Masco Industries Ltd. (Composite Unit)

221-223 Khartail, Shataish Road, Tongi, Gazipur.
(23.9212132N), (90.3870028E)

3rd November, 2015

Observations

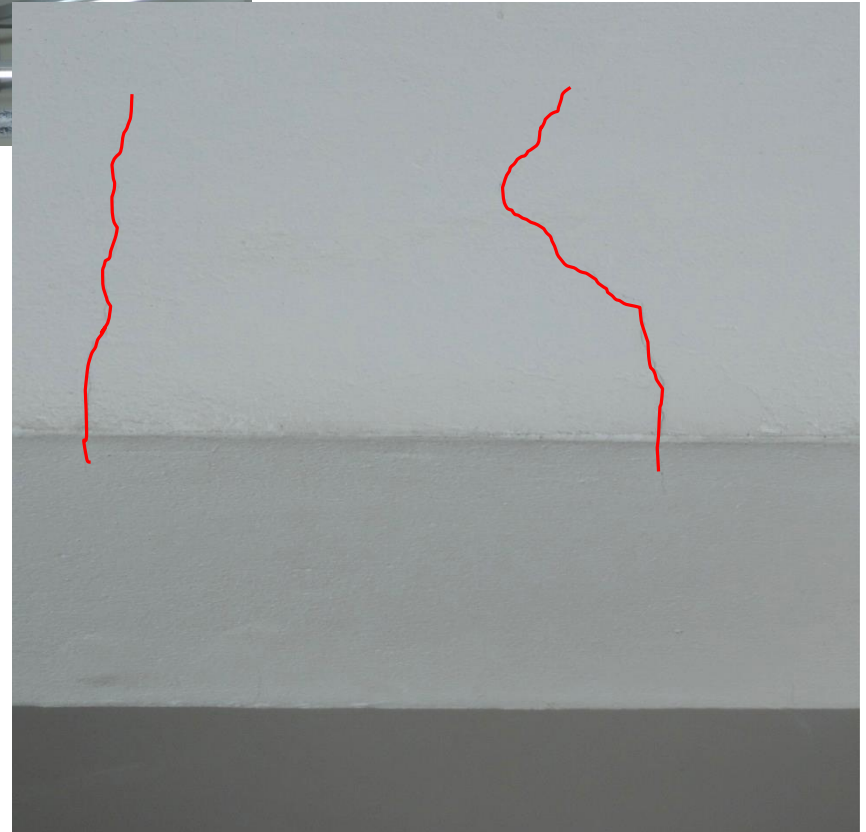
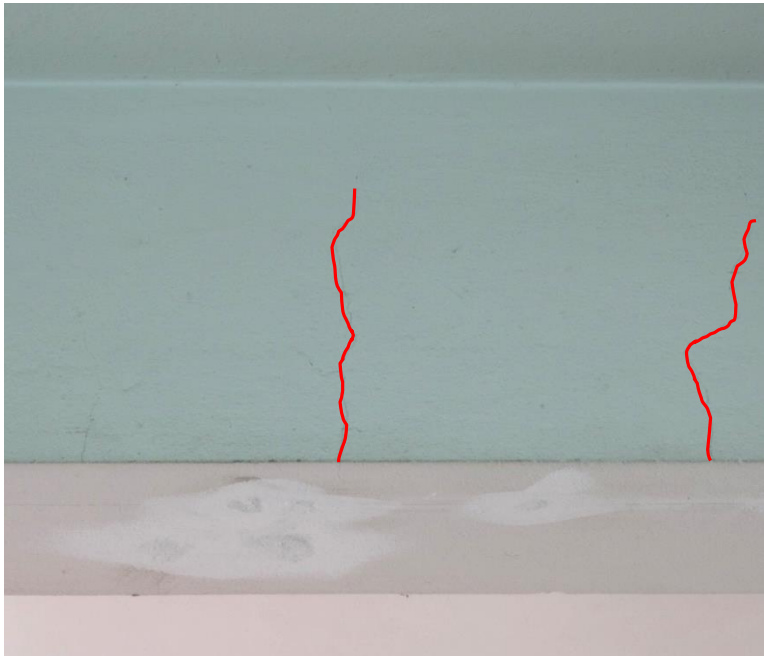
Lack of head restraint to external wall. The walls currently appear to cantilever from the floor slab
